**Some proposals of interpretations on
UN R51.03 following
GRB-64-15 - (France) Some proposals to improve
efficiency of road vehicle noise regulations**

Prepared by LF Pardo (France)

How to define Kick-down function ?

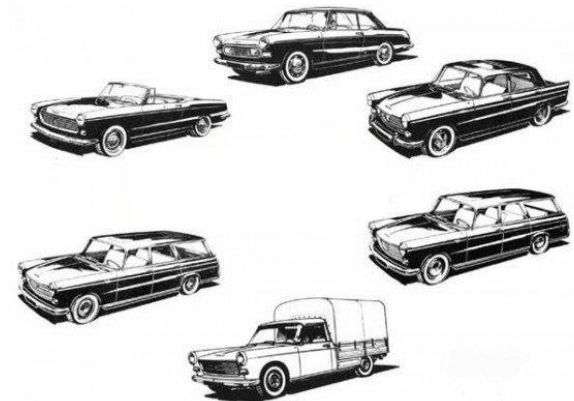
- Gear shifting
 - x gear shifting or
 - gear shifting to a gear ratio which is typically not used for the specified test condition in urban traffic
- Notch on pedal position close to end position
- ...

→ Could we precise kickdown function ?

Mass of the representative vehicle

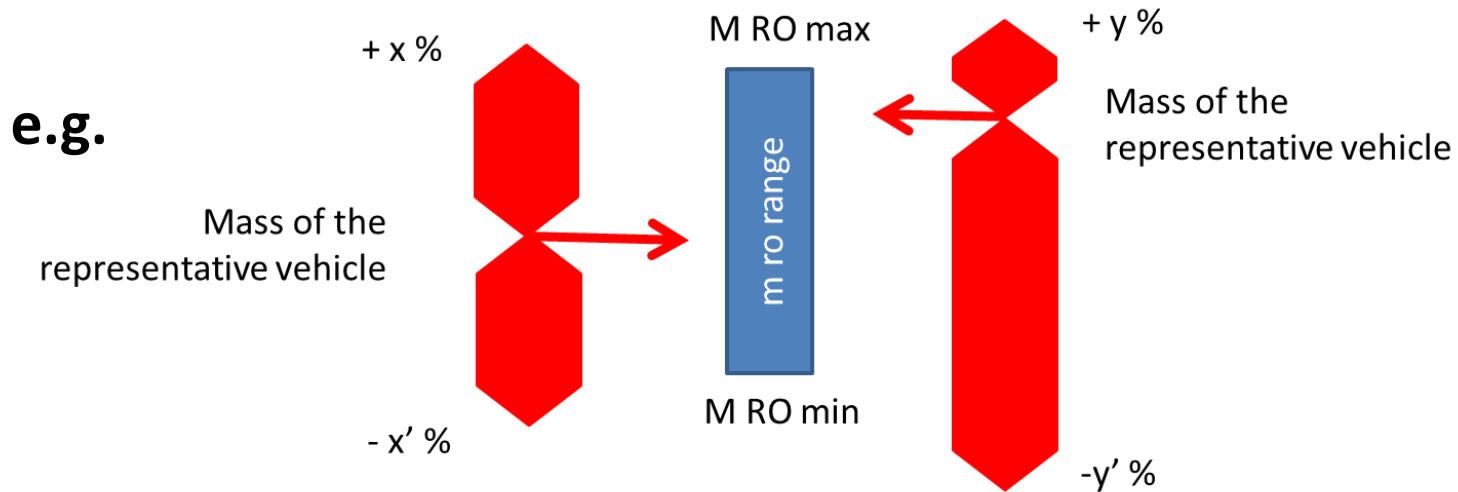
→ Could we consider range of m_{ro} ?

→ Could we precise how to select representative vehicle regarding range of m_{ro} ?

→ How to consider PMR, $a_{wot\ ref}$, a_{urban} , L_{urban} calculation... regarding m_{ro} range ?
